**Central Queensland Coal Project**  
**Chapter 3 - Project Changes and**  
**Responses to Regulator Comments**

**Central Queensland Coal**

**CQC SEIS, Version 3**

**October 2020**

**Figure 3-1: Project layout changes between SEIS v2 and SEIS v3**

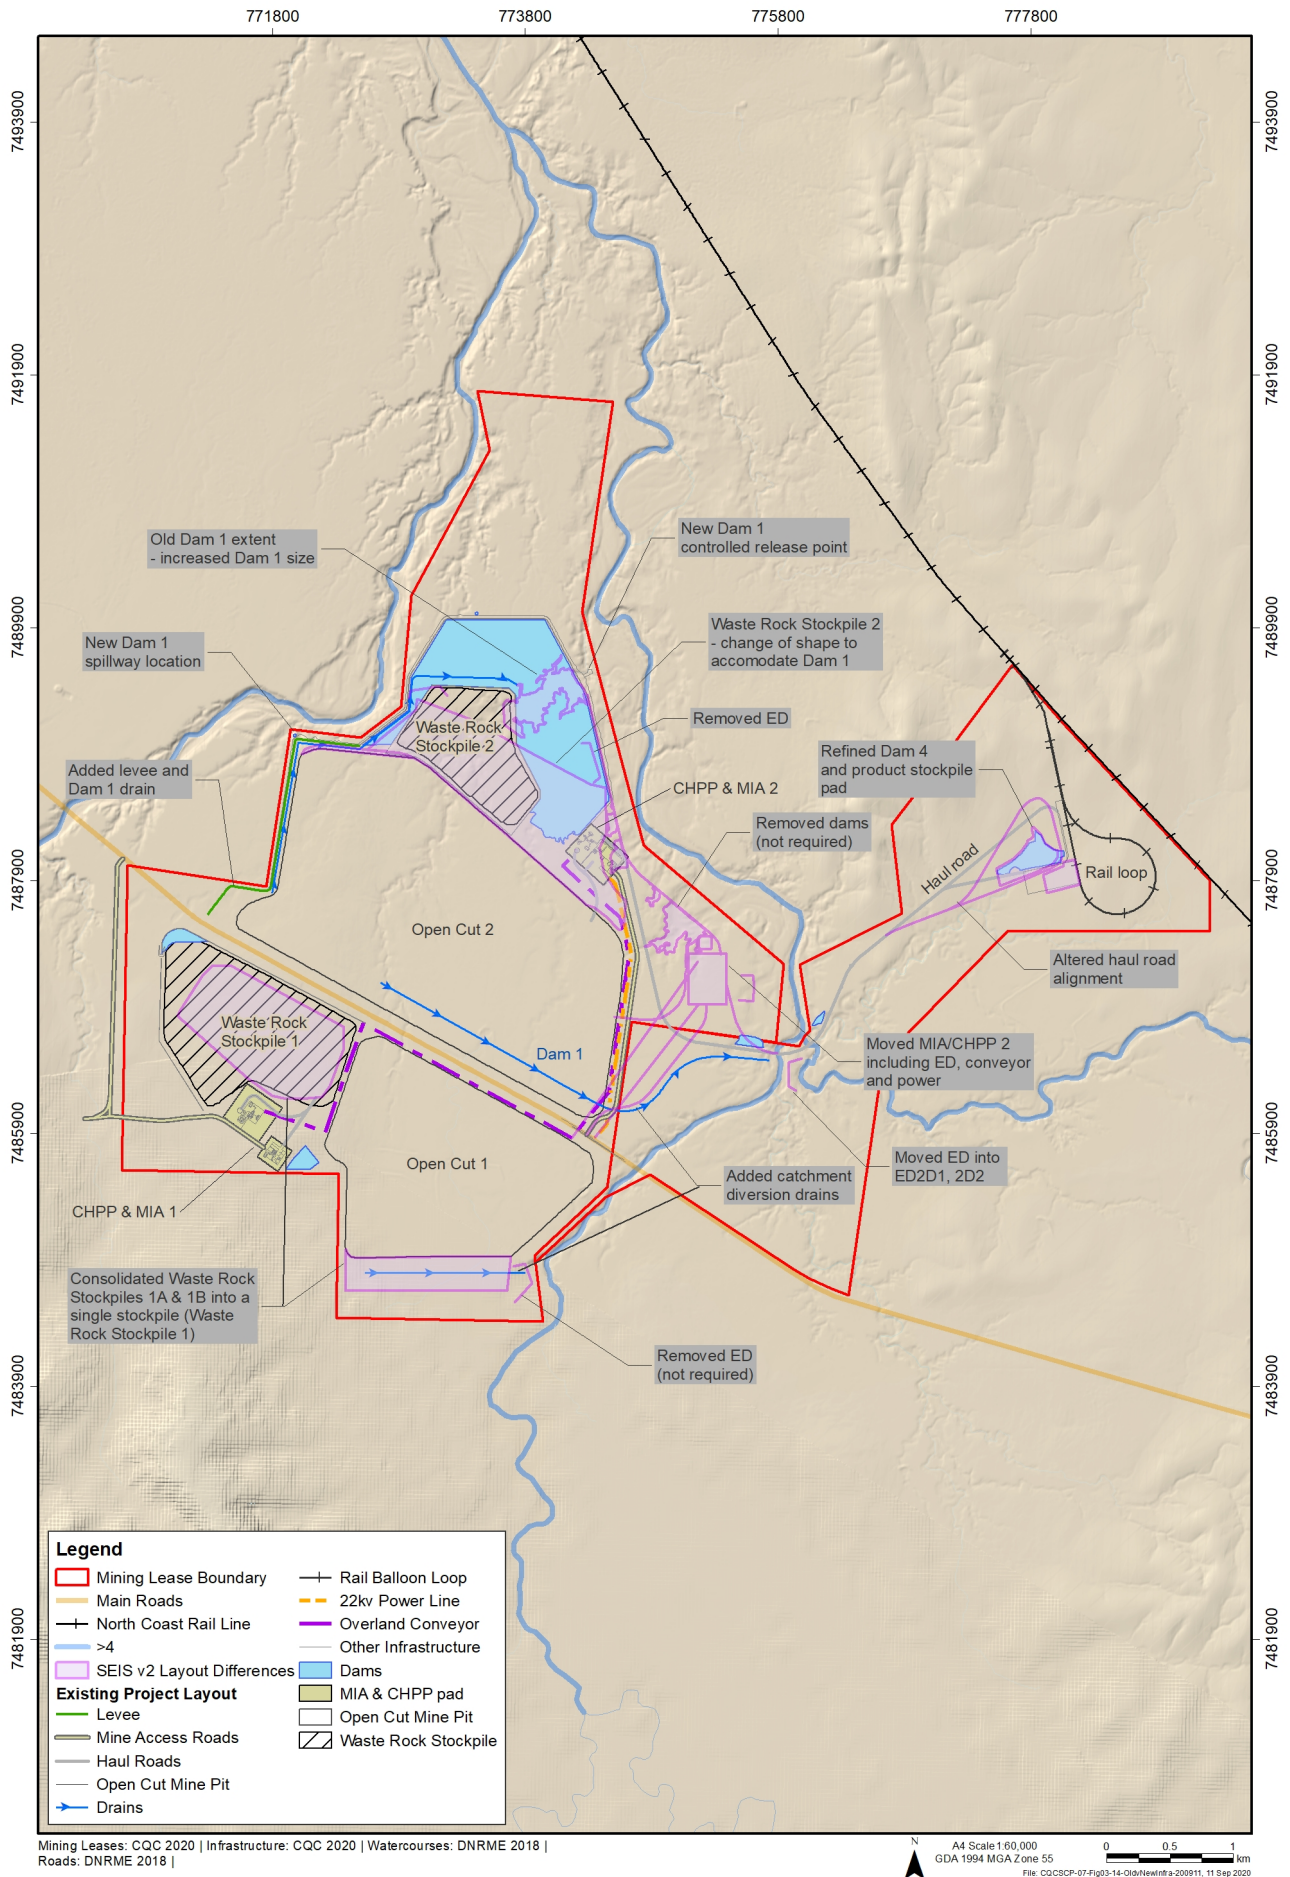
Throughout the EIS and SEIS process, refinement of Project design has sought to further avoid and minimise impacts on environmental values. Since the finalisation of SEIS v2, several additional changes have been made to Project layout (see Figure 3-1), operations and equipment to avoid and mitigate impacts on environmental values. The Project layout changes are shown in Figure 1 and include:

- excising 349 ha from the southern extent of ML 80187 to reduce the overall size of the Project Site
- revising the mine site water management system to increase storage capacity and hence minimise the potential for controlled and uncontrolled releases, while increasing the site water security for operations (see Figure 3-2):
  - as part of the above, consolidating the water storages and increasing the size of Dam 1 within areas of non-remnant vegetation and

- retracting the Open Cut 2 pit northern end wall by 40 m to the south to increase the buffer between the mine and endangered RE 11.3.11
- redesigning, reconfiguring or removing the former Waste Rock Stockpiles in order to minimise the area of disturbance, best facilitate later reworking to achieve reduced landform slopes post-mining, and locating them out of the flood zone to the greatest extent possible

**Figure 3-4: Broad Sound and the GBRWHA**

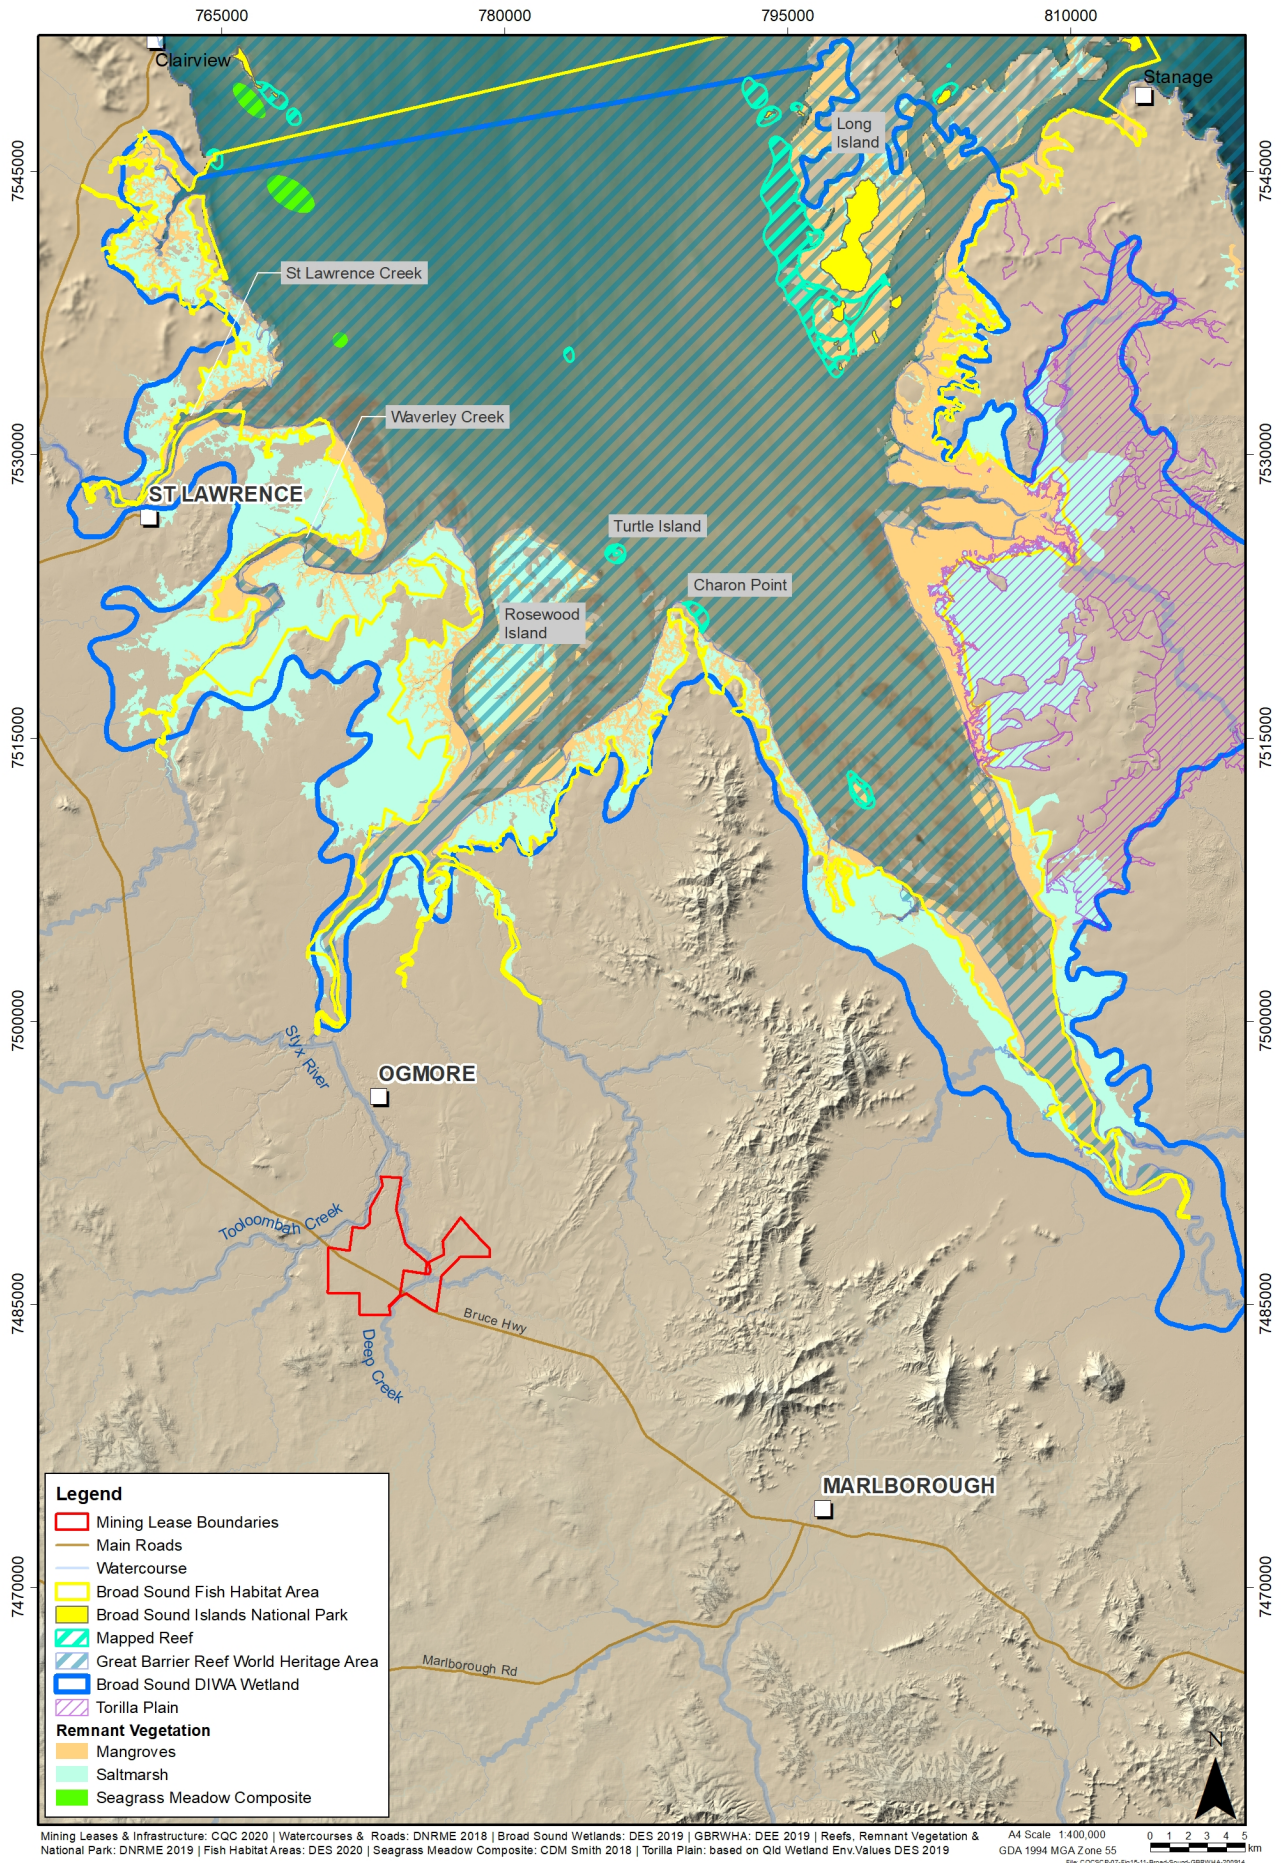
Correct Figure 9-93 to display the Broad Sound Declared Fish Habitat Area (FHA-047).

The figure is incorrectly referenced and incorrect.

Reference Figure 9-93 and correct the figure to include the Broad Sound Declared FHA (map attached).

The Broad Sound FHA is presented in 'Figure 15-11: Broad Sound and the Great Barrier Reef World Heritage Area (GBRWHA)' in Chapter 15 – Aquatic and Marine Ecology, and the nearest downstream boundary identified in 'Figure 9-8: Downstream sensitive areas' in Chapter 9 – Surface Water. These figures are also shown below in Figure 3-4 and Figure 3-5.

The Broad Sound FHA is presented in 'Figure 15-11: Broad Sound and the GBRWHA' in Chapter 15 – Aquatic and Marine Ecology. This figure is also shown below in Figure 3-4.

**Figure 3-7: Groundwater monitoring sites**

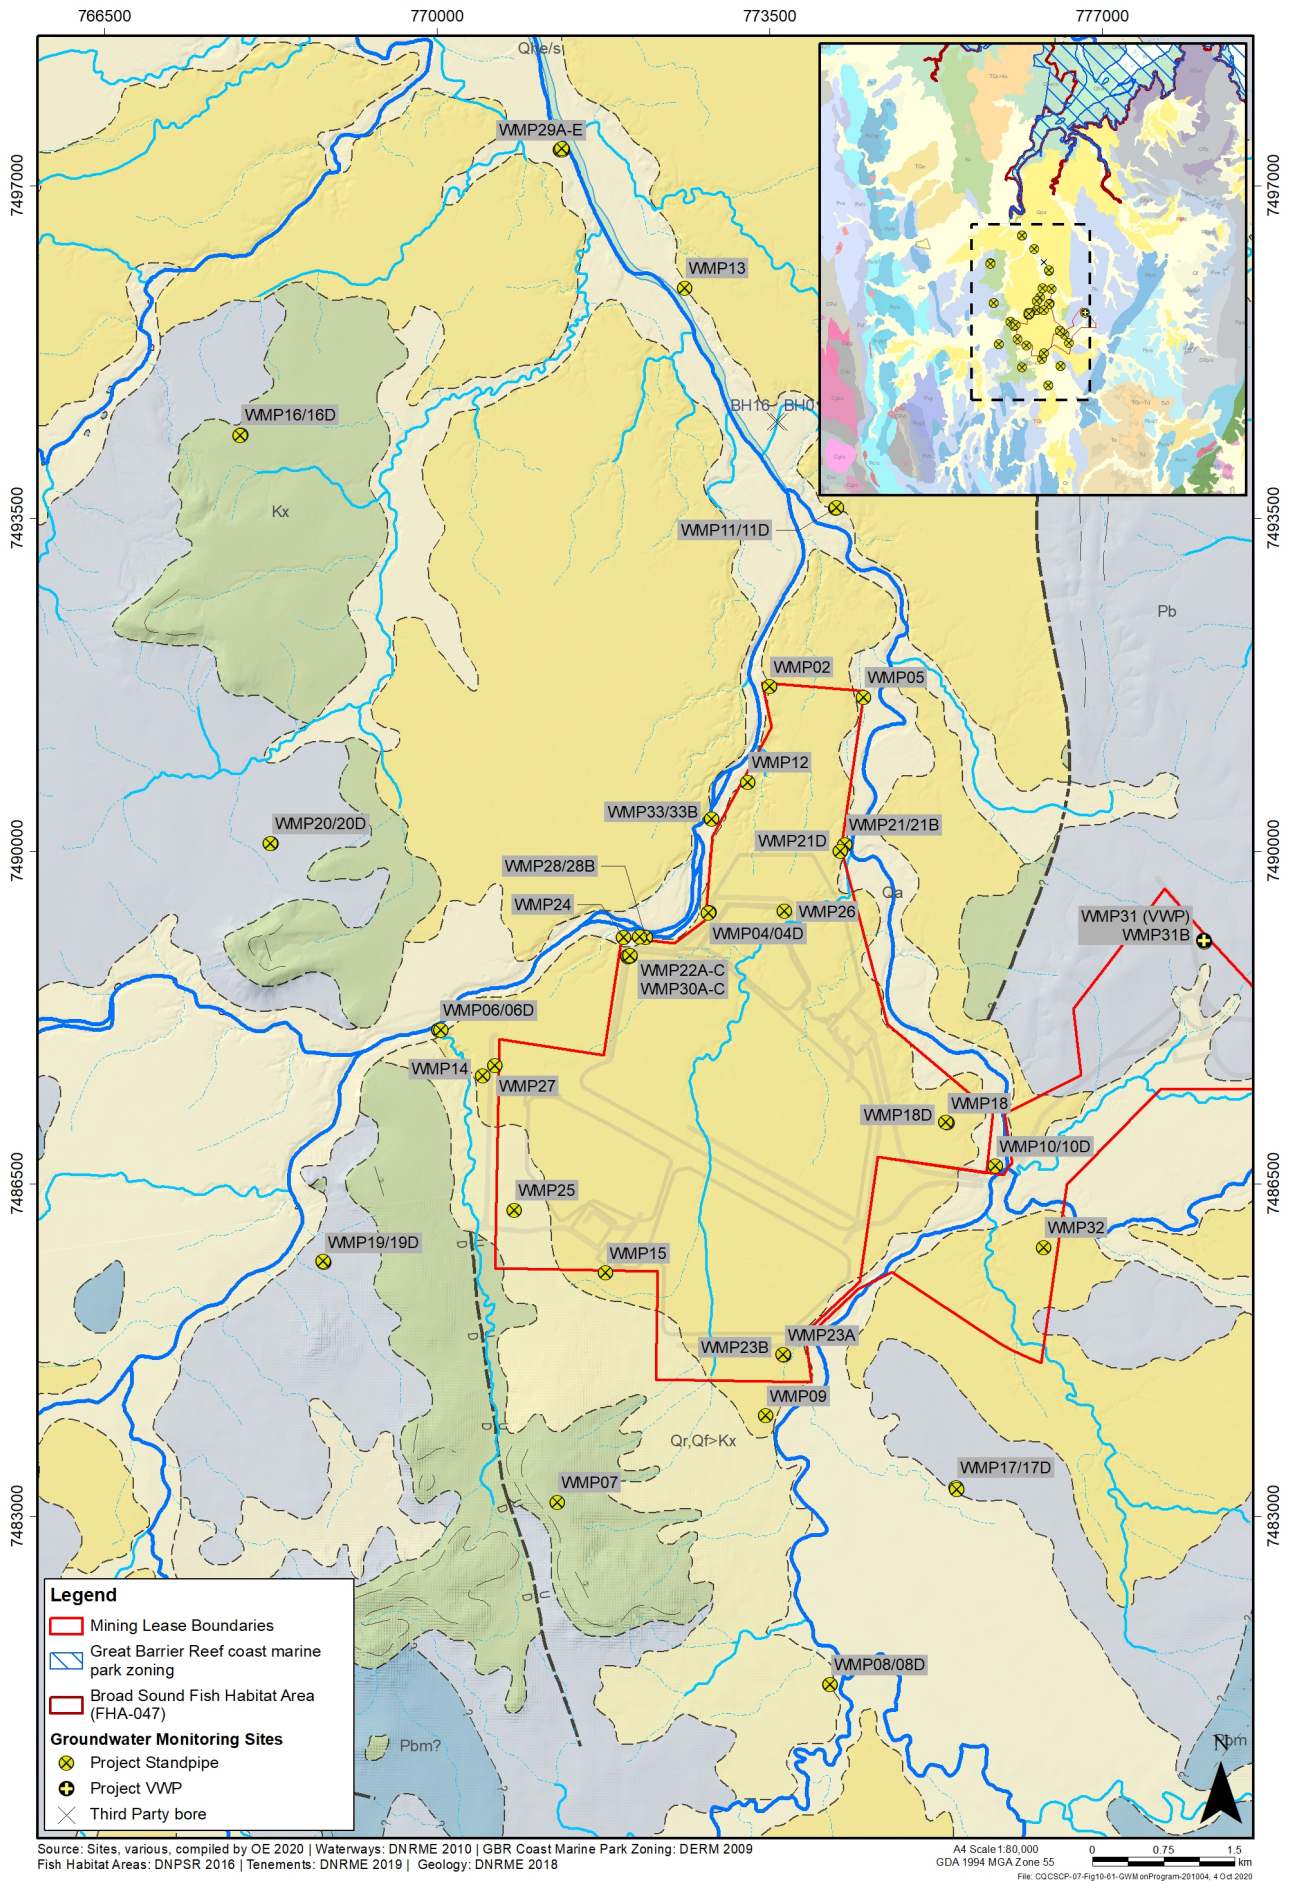
**3.6.2.6.6 *The GDEMMP must meet the following objective: To ensure all potential groundwater impacts from mine dewatering and mine water and waste storage facilities are identified, mitigated and monitored.***

Water level and pressure data is described in the GMMP. Water level data will be collected on a quarterly basis at the sites shown in Figure 3-7: Groundwater monitoring sites. These monitoring sites have been located such that groundwater level data is collected in all identified hydrostratigraphic units across the Project Area. The results of these monitoring measures are relevant to each type of GDE, with groundwater level at nearby bores providing an early indication of draw down potentially affecting the adjacent ecological values.

The GDEMMP, in co-ordination with the GMMP, will ensure that all potential groundwater impacts from mine dewatering and mine water and waste storage facilities are identified, mitigated and monitored. The impacts of the Project on GDEs is assessed in the SEIS v3 and in Section 5.2 of the GDEMMP. Section 5.3 of the GDEMMP outlines the mitigation and management measures to address the identified impacts, and 5.4 outlines the monitoring program for GDEs over the life of the Project.

**Figure 3-8: Extent of ground-truthed regional ecosystems and source of data**

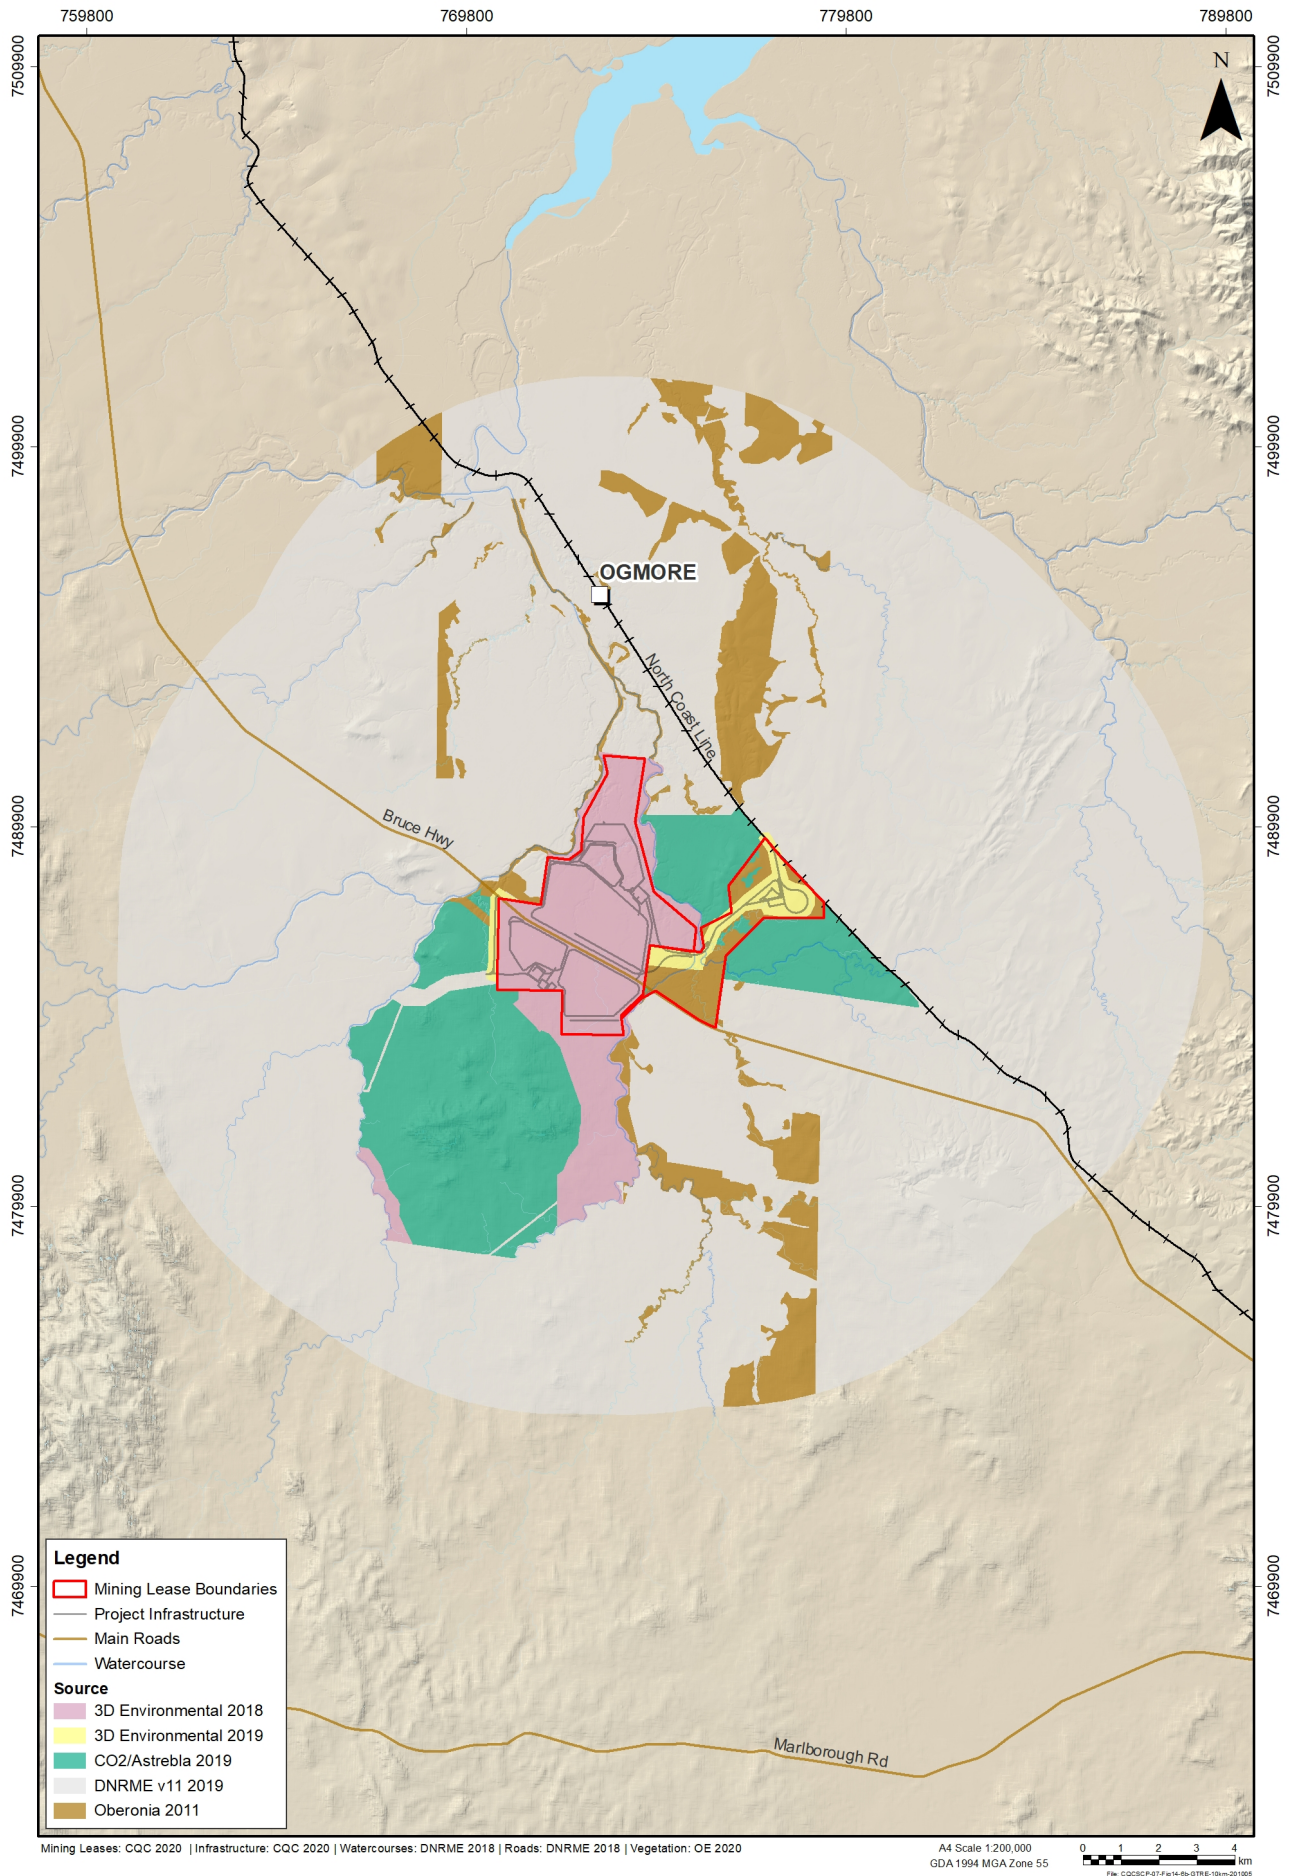
The recommendation on the last submission requested that the amended EIS provide further justification on the adequacy of the extent and location of flora surveys, noting that in "Figure 14-1" they seem inadequate. It appears that a different "Figure 14-1" has been inserted in the revised chapter which has the same survey locations overlaying vegetation that has been categorised in a different way. Further explanation of why these site locations are adequate has not been provided.

Provide a justification that the location and extent of the survey sites is adequate in areas mapped as "of concern" remnant vegetation. Additionally replace "Figure 1" with the amended map (Appendix 19) which classifies where the "of concern" remnant vegetation is, alongside the endangered and least concern vegetation.

Depending on their timing, surveys have been undertaken in accordance with either Neldner et al. (2005), Neldner et al. (2017) or Neldner et al. (2019), or Eyre (2015). Based on the survey events undertaken, Figure 14-6 shows the extent of ground-truthed RE within the Project Site and Near Surrounds, as well as the source of the data, and Figure 14-7 shows the ground-truthed RE present. These figures are replicated in Figure 3-8 and Figure 3-9 below.

Eleven REs were identified within the Project Site during field surveys and a total of 339 ha of remnant vegetation was mapped. Figure 14-6 and Figure 14-7 are replicated in Figure 3-8 and Figure 3-9, respectively. The ground-truthed RE mapping is now presented consistently throughout SEIS v3.
